DOCKETED	
Docket Number:	08-AFC-08A
Project Title:	Hydrogen Energy Center Application for Certification Amendment
TN #:	233603-9
Document Title:	Continuation of Amended AFC Volume III - HECA 9
Description:	*** These documents supersedes TN 65049 which was just the cover letter due to the fact the Amended AFC was too large to docket at the time. *** - Document was on proceeding webpage and is now moved over to the docket log.
Filer:	Raquel Rodriguez
Organization:	California Energy Commission
Submitter Role:	Commission Staff
Submission Date:	6/22/2020 12:59:32 PM
Docketed Date:	6/22/2020

Response to PM2.5 Cooling Tower Data Requests from CEC and USEPA

On June 21, 2010, SJVAPCD issued a Preliminary Determination of Compliance (PDOC) for public review and comment. The California Energy Commission (CEC) issued comments on the PDOC on August 3, 2010. Environmental Protection Agency (EPA) Region IX issued comments on the PDOC on August 16, 2010.

Figure 18-1
Particle Size as Function of Droplet Size

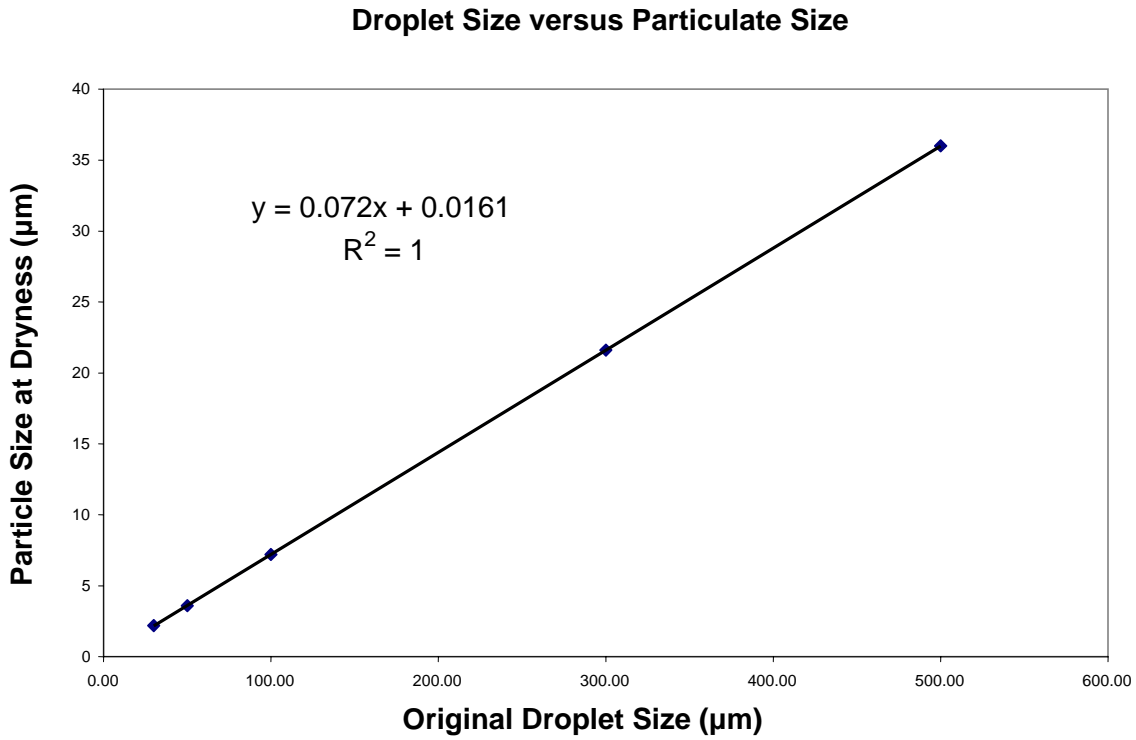
- overestimated due to the assumption that all PM emissions are comprised of PM₁₀.
2. The Applicant conducted a query for cooling towers in California on the CEIDARS³. The query results show that all of the cooling towers from different source categories in California in 1995, 2000, 2005, and 2008 have an average PM_{2.5}-to-PM₁₀ ratio of 0.636, and an average PM_{2.5}-to-PM ratio of 0.441 (see Attachment CEC-3-1). In addition, the Applicant, with assistance from CARB emission inventory staff (Gabe Ruiz and Darryl Look), gathered all the California power plant cooling tower emissions from CEIDARS (see Attachment CEC-3-2). Because only PM emissions were measured, PM_{2.5} emissions are estimated from PM emissions. Attachment CEC-3-2 and Applicant discussions with CARB staff confirmed that the 0.7/0.6/0.42 PM/PM₁₀/PM_{2.5} ratios were applied to most of the power plant cooling tower emission estimates. The average PM_{2.5} fraction of PM₁₀ is 0.633, and the average PM_{2.5} fraction of PM is 0.478 for all power plant cooling towers in California. The PM_{2.5} fractions of PM₁₀ from the CEIDARS database for cooling towers from power plant cooling towers and from different source categories are very similar to the fraction the Applicant used in its cooling tower PM_{2.5} emissions estimations. Therefore, in calculating the cooling tower PM emissions, the Applicant has accurately presented the PM_{2.5} portion of PM₁₀ emissions, and furthermore, by assuming 100 percent of the total PM emissions to be PM₁₀, the Applicant has significantly overestimated the PM_{2.5} emissions.

A U.S. EPA report provided a calculated estimate on the effect of evaporation on droplet size, which presented an equivalent PM size generation as a function of droplet size (U.S. EPA, 1998) (see Figure 18-1 and Attachment 18-1).

As shown in Figure 18-2, PM_{2.5} emissions from cooling tower drift using the U.S. EPA methodology are approximately 40 percent of the total particulate emissions. Figure 18-2 shows that the HECA Project's assumption that PM_{2.5} emissions are 60 percent of the PM₁₀ (which was assumed as 100 percent particulates) is indeed conservative.
